CS Memorandum No. 1336

Subject: Configuration Management Board Meeting No. 109

CMB Meeting Minutes #109

SUBJECT: Configuration Management Board Meeting # 109 – Rev. No. 0

THIS PROVISION APPLIES FOR ANY PERMITS REQUIRED BY THE CITY OF SAN FRANCISCO. THIS PLAN SHALL BE APPROVED BY THE CITY OF SAN FRANCISCO.

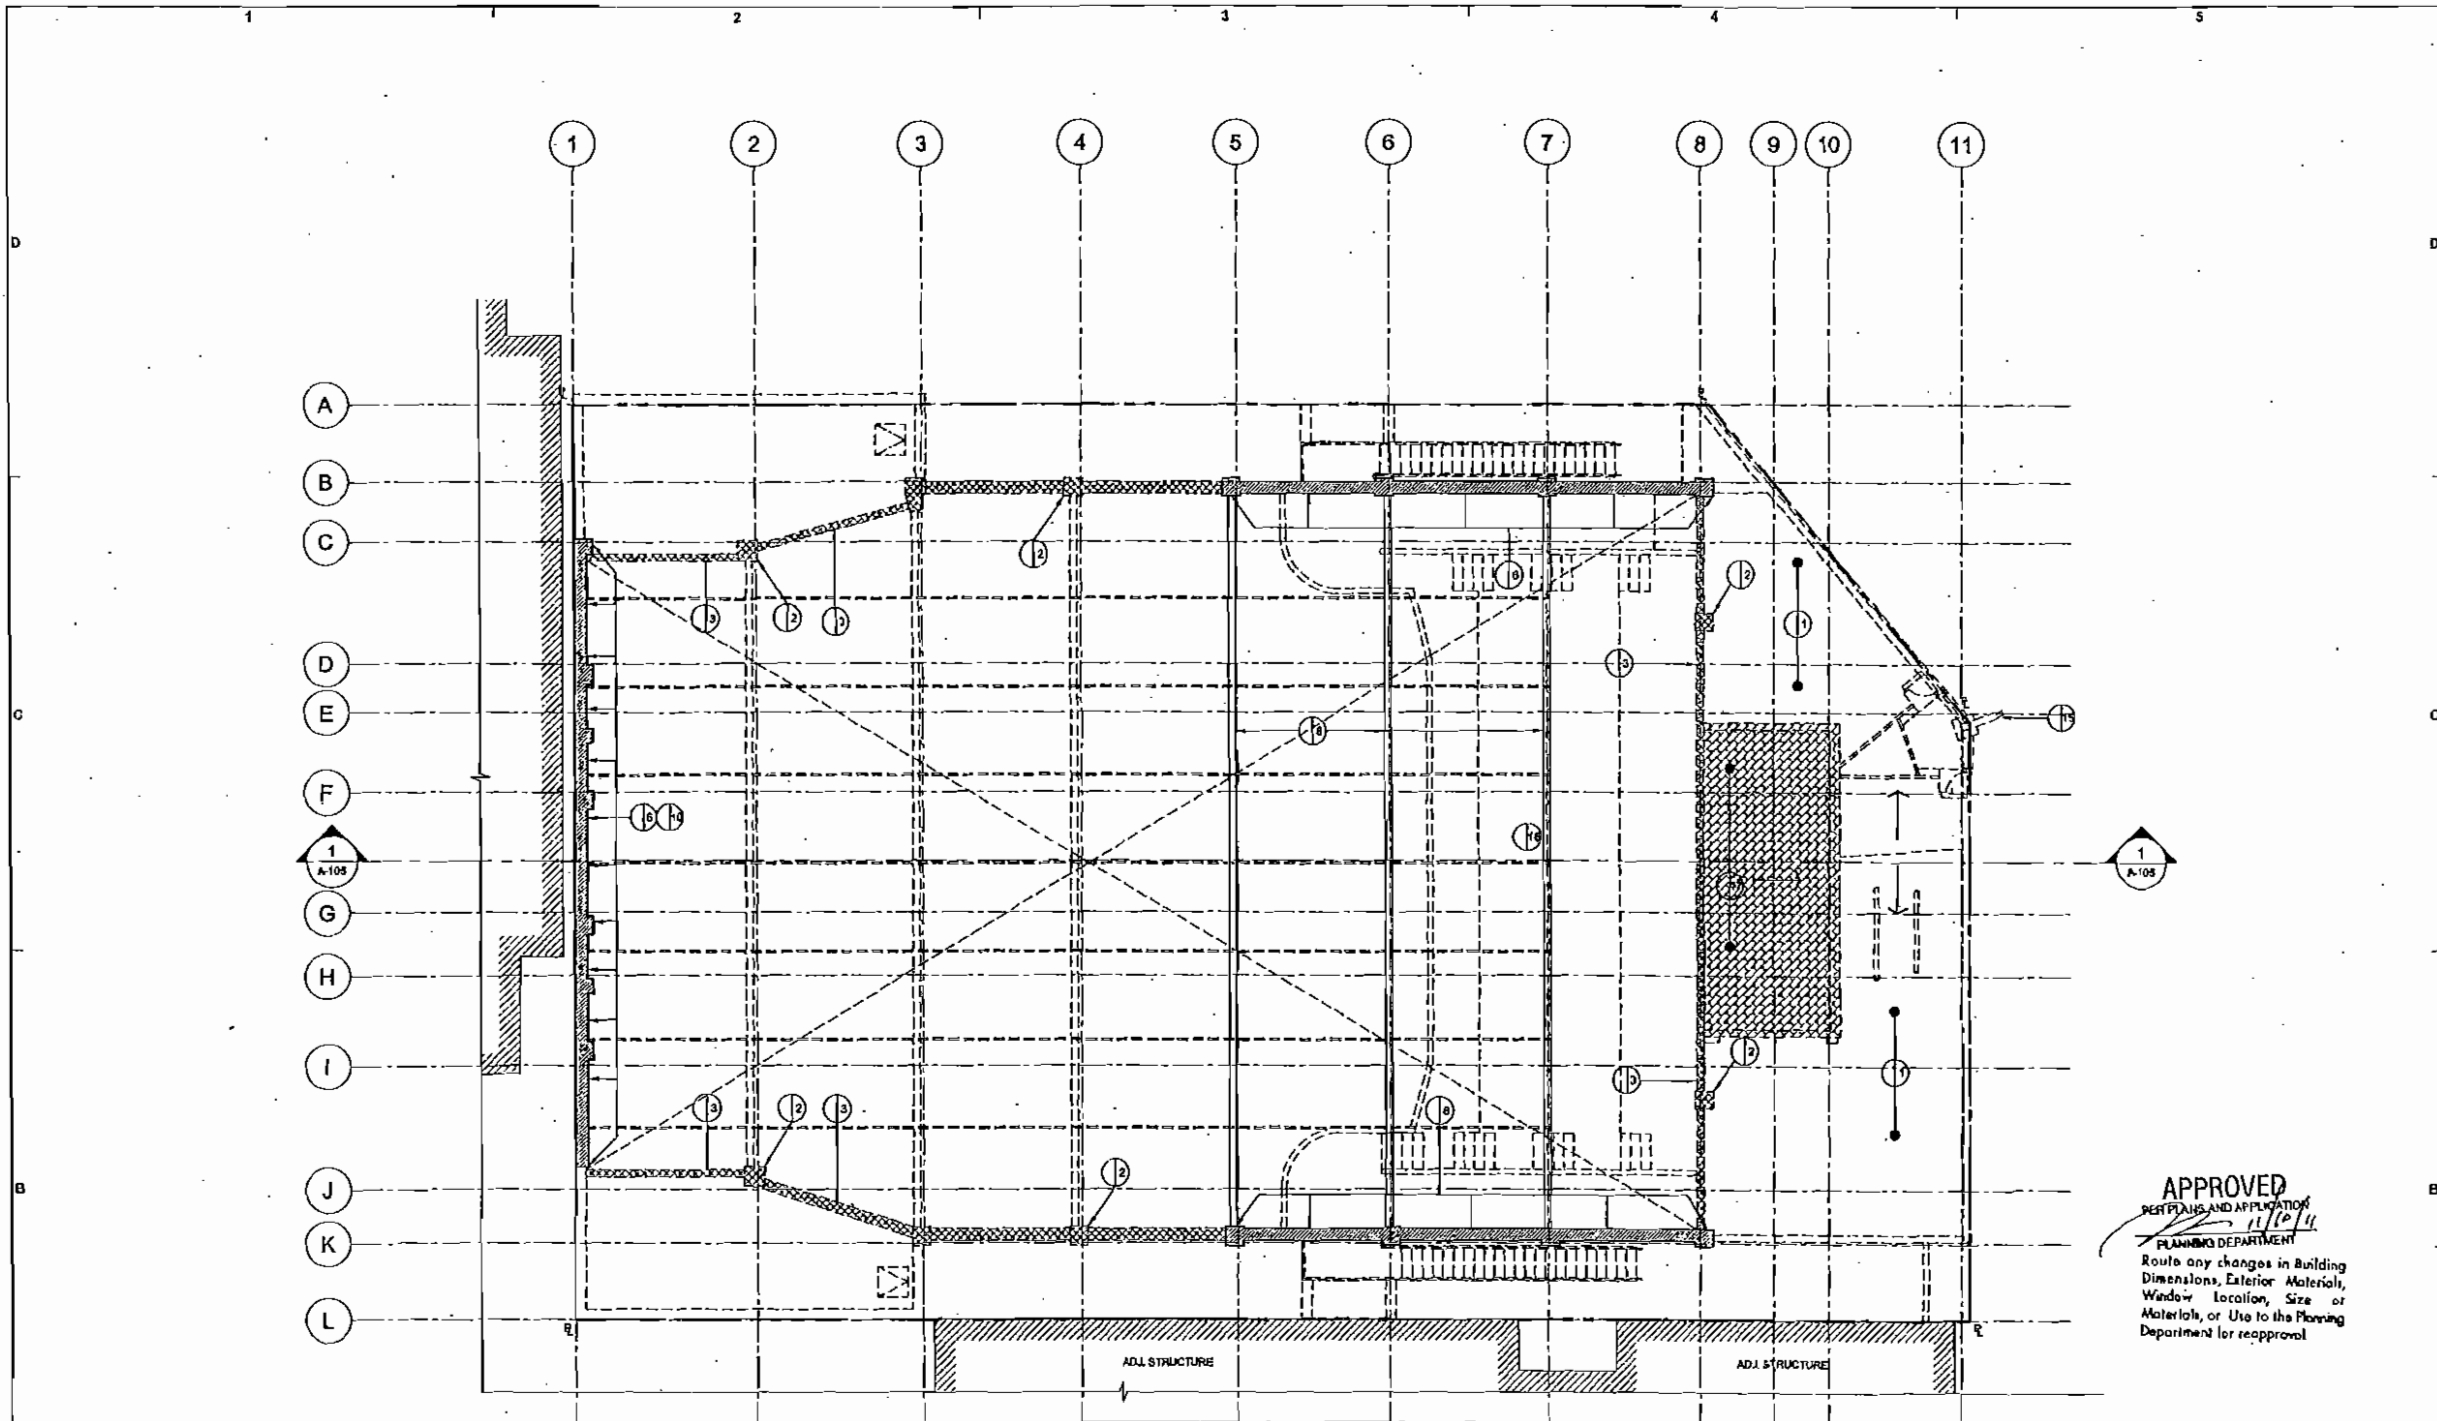
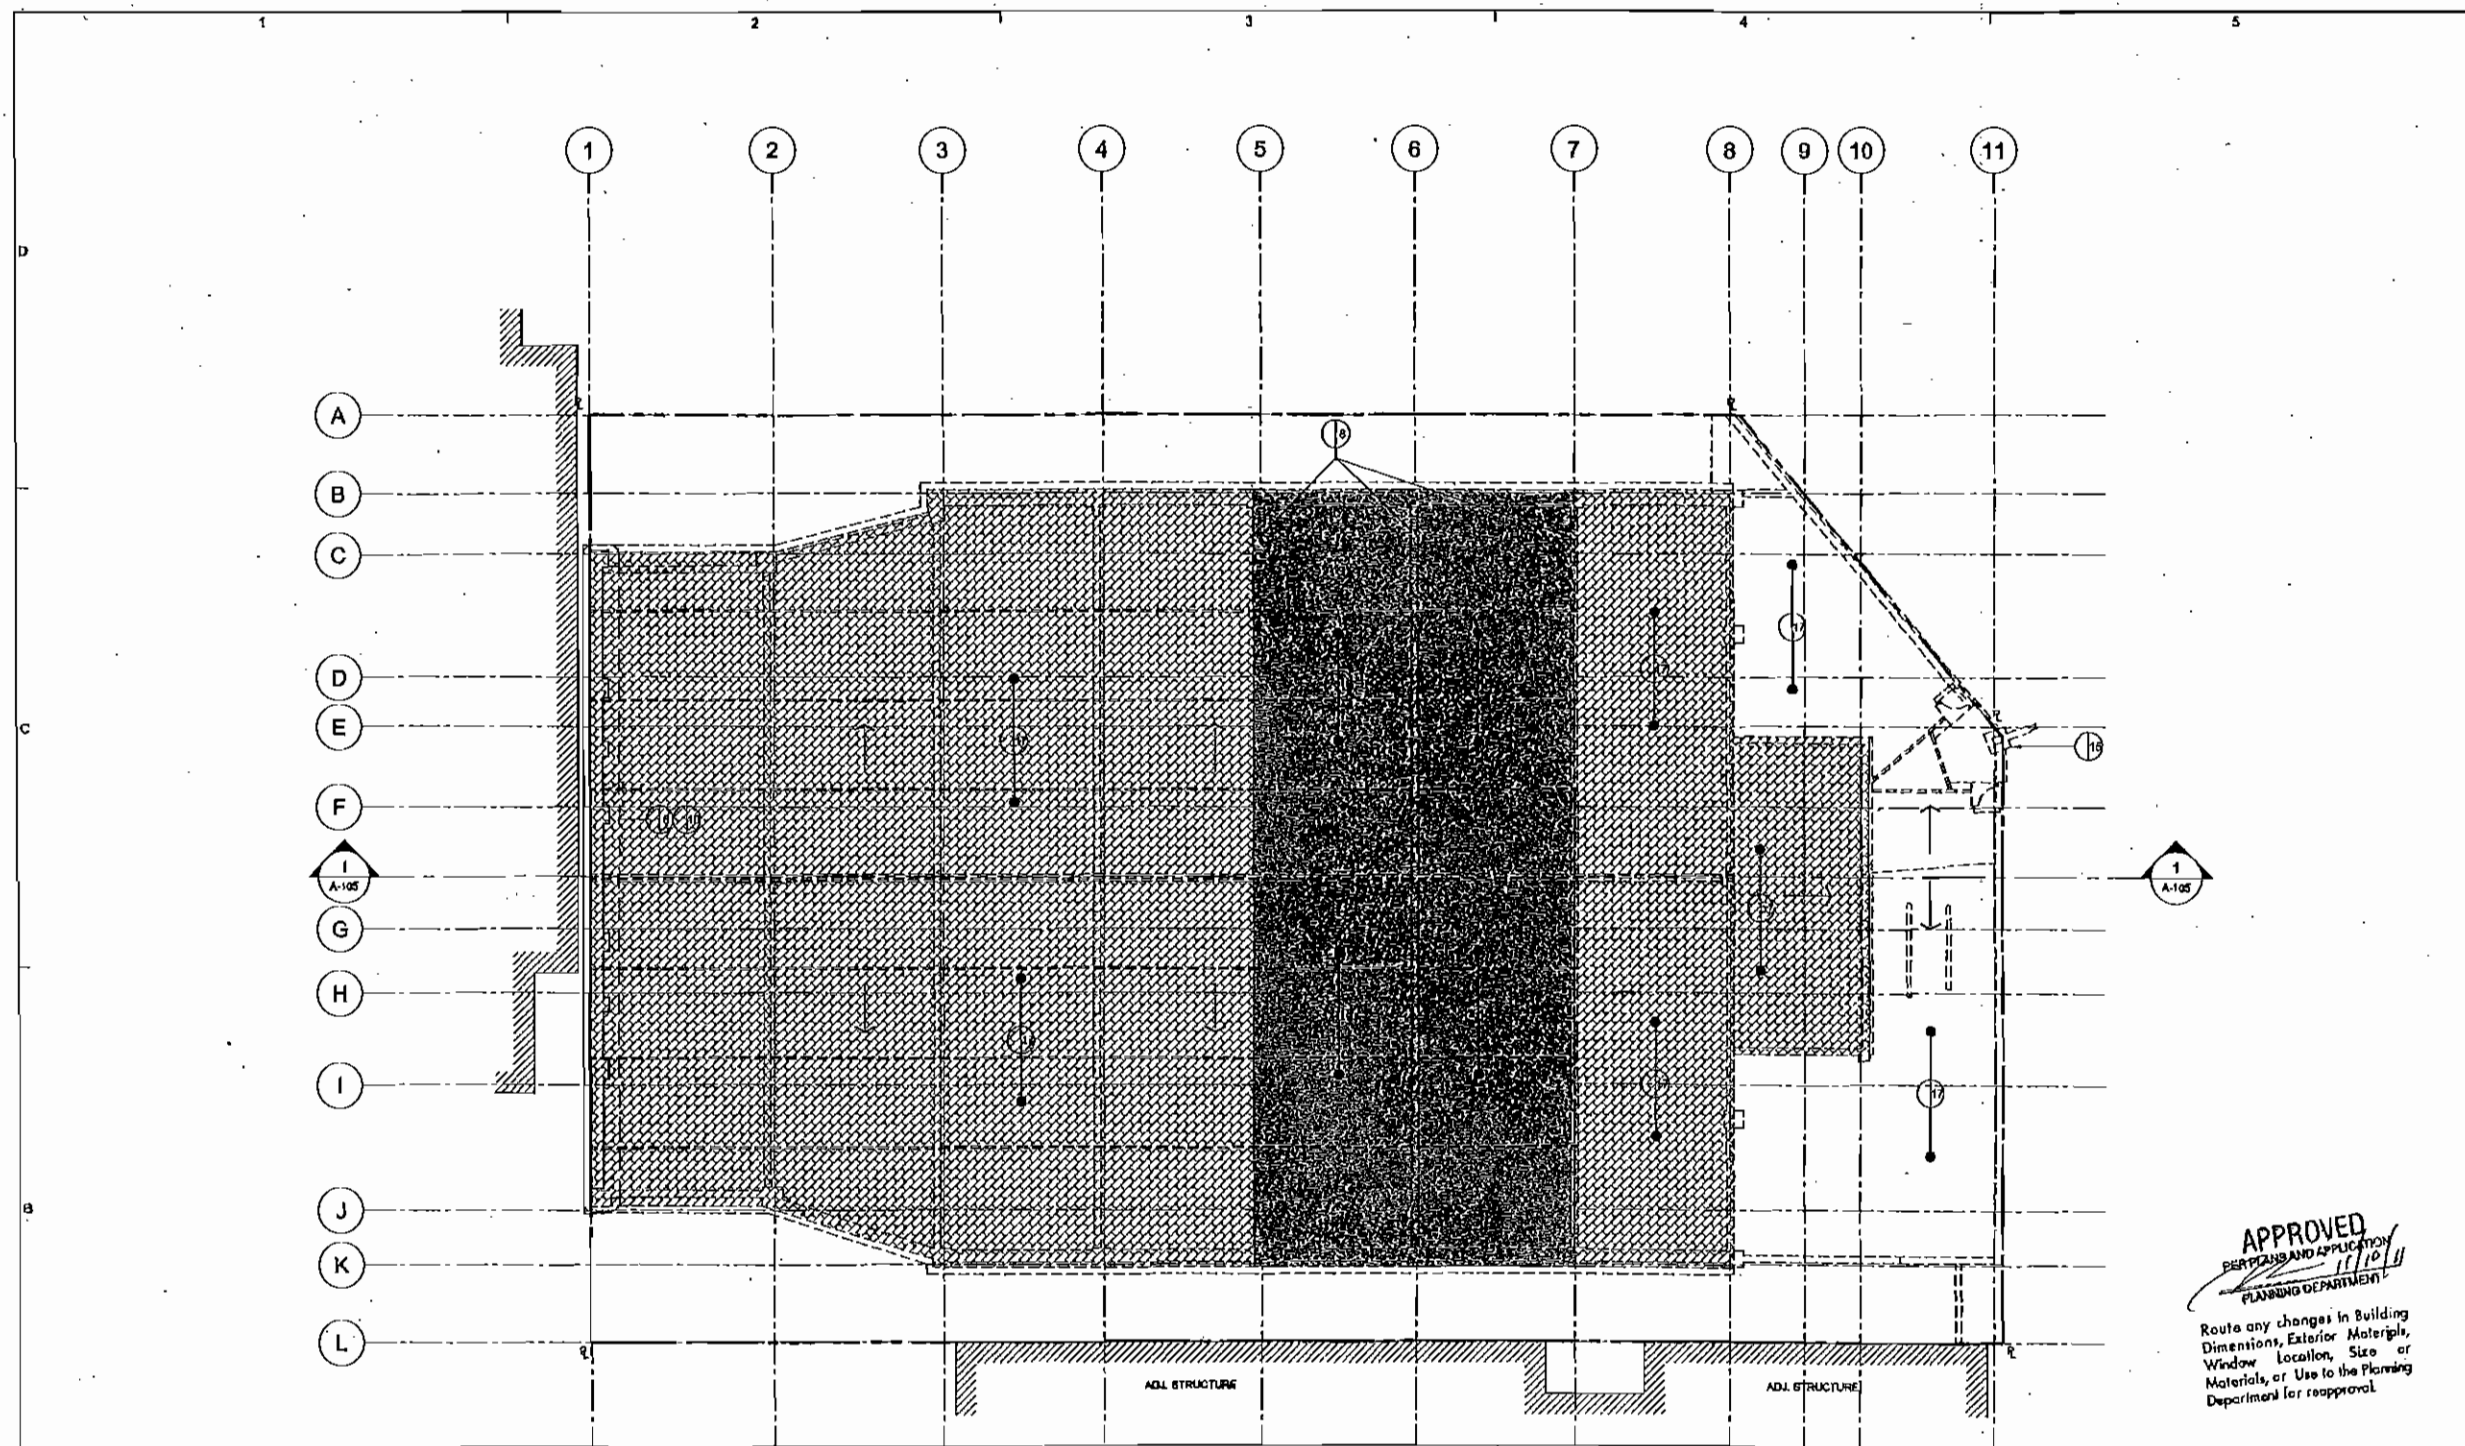
- Design and demolish existing building at 1731-1741 Powell Street. Demolition to include entire building; roof trusses and perimeter walls are not to be retained as shown in attached representative Demolition Plans.
